Sent: 2/05/2021 7:27:52 AM
Subject: 13 Pacific Road Palm Beach NSW 2107 DA 2020/36 Written Submission:
Letter of Objection & Written Submission to NBLPP Submission: Casey
Attachments: NBLPP Submission Casey.docx;

S U B M I S S I O N : C A S E Y
a written submission by way of objection to DA 2020/1136

Re:
13 Pacific Road Palm Beach NSW 2107
DA 2020/1136

Written Submission: Letter of Objection & Written Submission to NBLPP
Submission: Casey

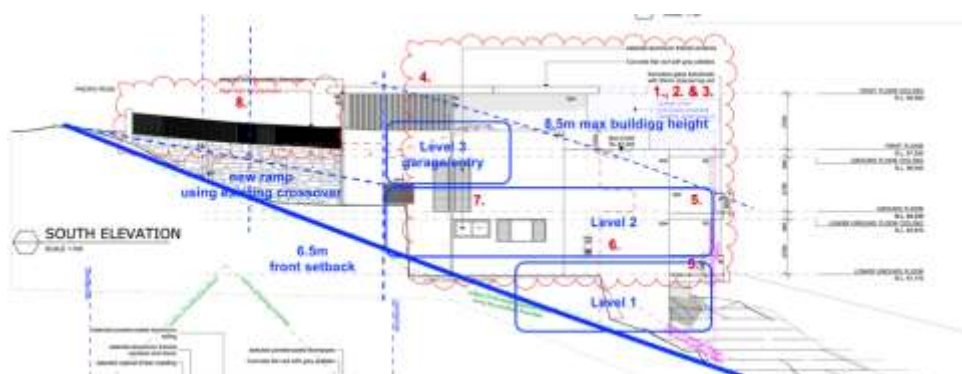
We contend that the excessive height above 8.5m is not 'minor' and fails LEP 4.3 2D [a], and fails the objectives LEP 4.3 [1] [a] desired character of locality, [b] compatible with neighbours, [c] overshadowing, and [d] street view.

*Sketch against Roof Plan Rev B: Extensive zones exceed the 8.5m control at both upper levels, shown edged in green on the above sketch. **The area over 8.5m is not 'minor' and fails LEP 4.3 2D [a], and fails the objectives LEP 4.3.** Note that existing and neighbouring dwellings maintain the 8.5m height control.*

1. The extensive zones of the building above 8.5m building height, at the upper two storeys, that will:
 - a) be significantly and noticeably higher than existing surrounding development from vantage points below the subject site;
 - b) create a jarring and unsympathetic outcome set against neighbouring houses that comply with the 8.5m control;
 - c) take public domain street views of the ocean

- d) take winter sun from our north facing windows, and external private open space, refer appendix A, particularly in the zone above the 8.5m building height control;

- Reduce Building Height not to exceed 8.5m.
- Compliant Front and Side Setbacks
- Compliant Building Envelope
- Maintain top of roof to match existing roof height at RL 88.27, and reduce upper-level roof not to exceed the RL 80 contour in alignment to ensure full compliance to standards
- Reduce floor plates below to c. RL 85.1 and c..82.10 and to follow the alignment of proposed ground floor in Rev B drawings
- Maintain existing ramp entry, or a new maximum grade AS ramp using the existing crossover, being the lowest level at the street frontage, with enclosed garaging to the northern side
- All windows to the South Elevation to have 1.7m sills, and obscured glass or privacy screens.
- Decks to have 1.7m high privacy screens facing the side boundary
- Landscaping in southern side setback to proposed wall height
